Memo

Re: Responses to comments from Zarin & Steinmetz, regarding Garvies Point PUD
Amendment and E/F Site Plan Applications

Date: May 11, 2021

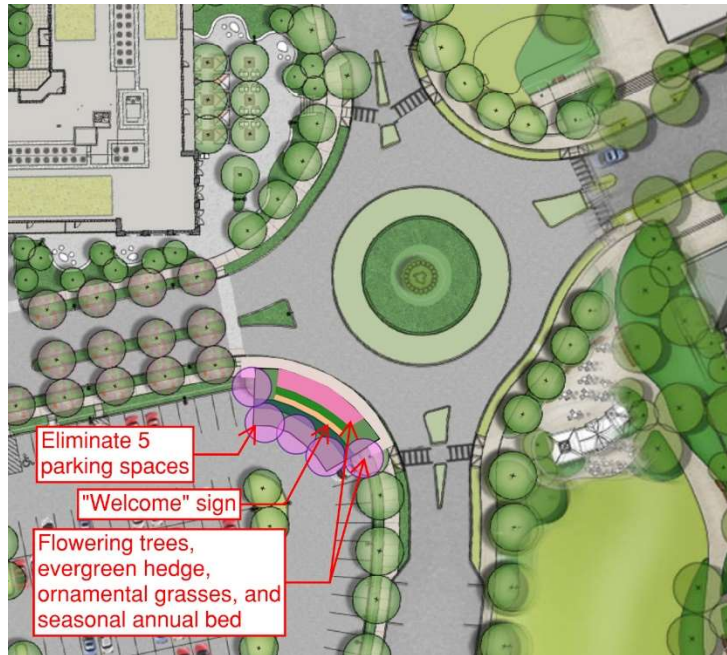
9. Clarify what dimensional requirements may not be met in the Block D surface parking lot.

RESPONSE: *As discussed in other response memos, the Applicant has adhered to the City of Glen Cove's request to maximize parking at Block D, to maximize the potential ridership of the ferry service. This has entailed a reduction of the parking lot landscaping requirements that may have been stipulated in other zoning districts.*

However, in response to the discussion held between Saratoga Associates and the Applicant on 5/7/2021 and as detailed in the MPFP response memos, the Applicant is proposing to convert 5 parking spaces into signage and plantings at the northeast corner of Block D. See below for a graphic, which will be further detailed in a revised submission:
